Office Action Summary	Application No. 10/695,295	Applicant(s) GONZALES ET AL.	
	Examiner QUYNH-NHU H. VU	Art Unit 3763

DETAILED ACTION

Claims 1-2, 4-10 are rejected under 35 U.S.C. 102(b) as being anticipated by Weinstein et al. (US 5,460,616).

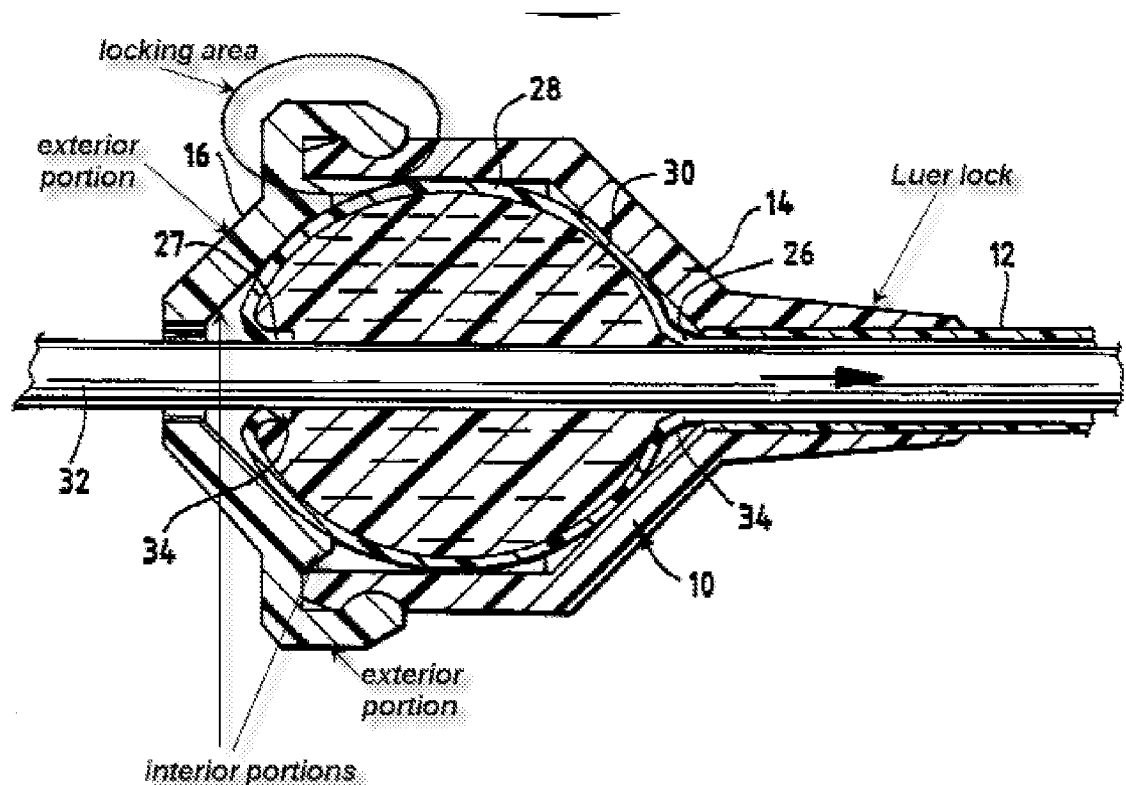
Weinstein discloses, see Fig. below, a housing including a proximal housing portion and a distal portion 14 to define a gel cavity 30. a seal material disposed in the gel cavity, the seal member including a gel having non-compressible characteristics; a proximal guide tube 16 extending axially proximally from the proximal housing portion; the proximal guide tube facilitating insertion of a surgical instrument into the seal material; a distal guide tube (closes to Luer lock arrow) extending axially distally from the distal housing portion, the distal guide facilitating retrograde insertion of the surgical instrument into the surgical seal; wherein the proximal guide tube includes exterior portions extending proximally of the proximal housing portion and interior portions extending distally of the proximal housing portion. Weinstein

discloses a luer lock (see Fig. below) coupled to the distal guide tube 14 or 12, the distal guide tube being included within the luer lock.

Regarding claim 10, Weinstein discloses a first housing portion 16, a second housing portion 14; a gel 30 disposed within the gel cavity and having properties including flowability and incompressibility, the gel having characteristics for creating a pressure on the instrument to form a seal with the instrument, and means for moving the second housing portion relative to the first housing portion to increase the pressure of the incompressible gel on the instrument and create a locking force tending to inhibit movement of the instrument relative to the valve (see Fig. below, or col. 1, line 47)

In response, Examiner clearly point out in Fig. 3 above.

In response, Because Applicant does not clearly explain the purpose or function of node in the device, nor show the node clearly in Figs. 6-7. Therefore, Examiner interprets as broadly that the element 27 as a node. Furthermore, Fig. 3 clearly shows that the sealing material having axially channel when instrument facilitate placing an axial channel.

In response, device of Weinstein clearly shows in Fig. 3 that the first and second housing portion 14, 16 engaged to each other and one skill in the art would recognize that it will produce or increase the pressures of the gel on the instrument and there a locking force to engage the first and second portion together to inhibit movement of the instrument relative to the valve (see Fig. above)

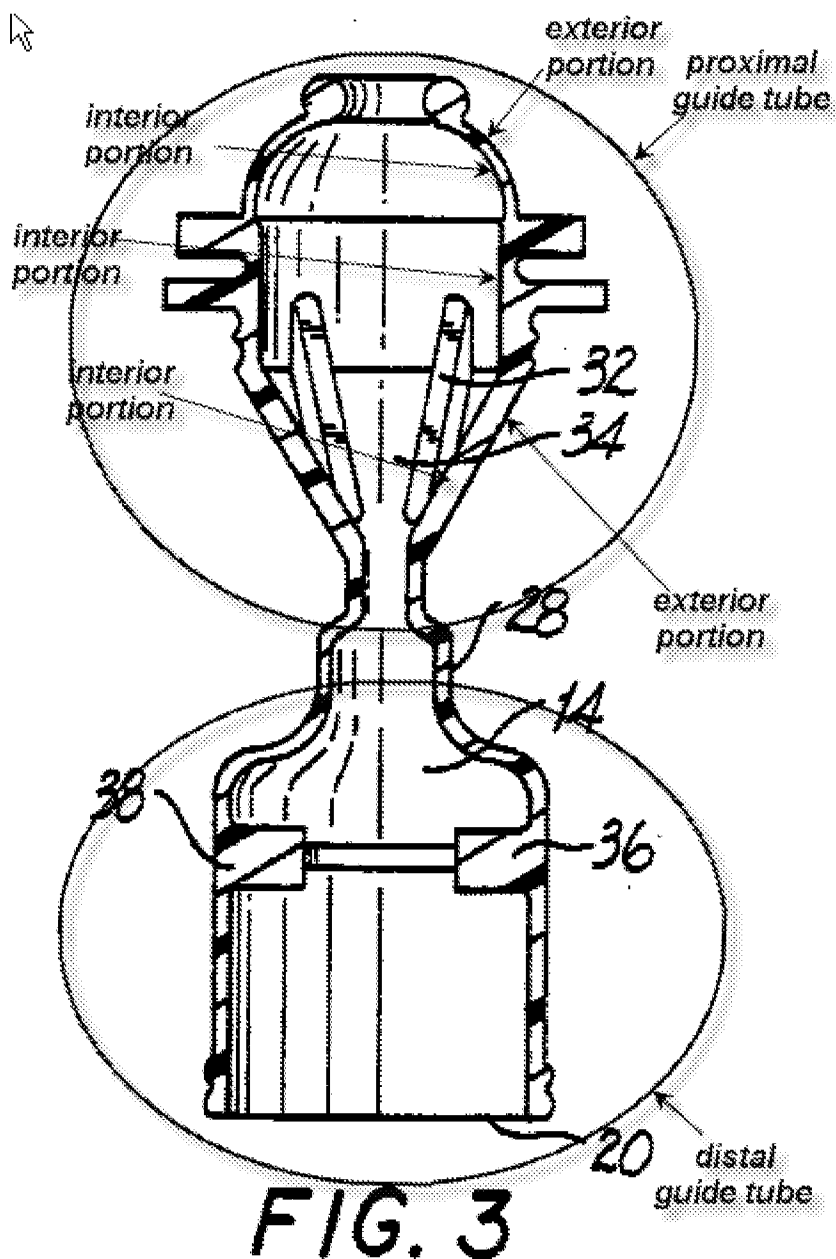
Regarding claims 4-5, the seal material defines 42 defines an axial channel through the gel, and the proximal guide tube contacts the seal material around the axial channel at the proximal end of the valve, see Fig. 7; the seal material and the first housing portion form a subassembly free of a circumferential seal between the seal material and the first housing portion; and subassembly to form a circumferential seal between the gel and the first housing portion; the proximal guide tube applies a force to seal material in subassembly to form a circumferential seal between the gel and the first housing portion, see Fig. 7.

Regarding claims 6-9, Gravener discloses that a first housing portion defining a gel cavity; a node 32 (Fig. 3) or 46 (Figs. 10, 14-16) an axial channel; a subassembly including the seal material disposed in the gel cavity; a second housing portion disposed juxtaposition to the first housing portion and applying a force to the seal material in the subassembly, the force being of a magnitude sufficient to place the channel of the seal material in a closed state (Figs. 8-9); wherein the guide tube (proximal guide tube) contacts the node 32 or 46 of the seal material to apply the force to seal material (Figs. 8-16).

In response, according to www.answers.com define the tube: as a hollow cylinder, especially one that conveys a fluid or function as a passage. Device of Garvener including a hollow cylinder and able to convey a fluid or function as a passage also. See Fig above.

In response, please see Fig. above.

In response, Applicant does not clearly disclose the node or function of the node. Furthermore, Applicant does not show clearly the node in Figs. 6-7, therefore, Examiner interprets broadly that the node is as protuberance, swelling, a knob, or a knob. Therefore, element 32 or 46 can be read as a node.

Gravener clearly discloses that the seal material having an axial channel (Figs. 6-16).
